FF-S-86E
AMENDMENT 3
JULY 9, 1990
SUPERSEDING
Amendment 2
September 29, 1989

FEDERAL SPECIFICATION
SCREW, CAP, SOCKET-HEAD

This amendment, which forms a part of FF-S-86E, dated May 29, 1987 is approved by the Commissioner, Federal Supply Service, General Services Administration, for the use of all Federal Agencies

VIEW 5A

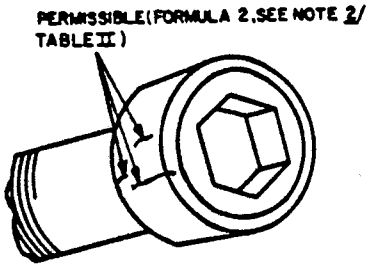
Figure 5, View 5A

DELETE AND SUBSTITUTE:
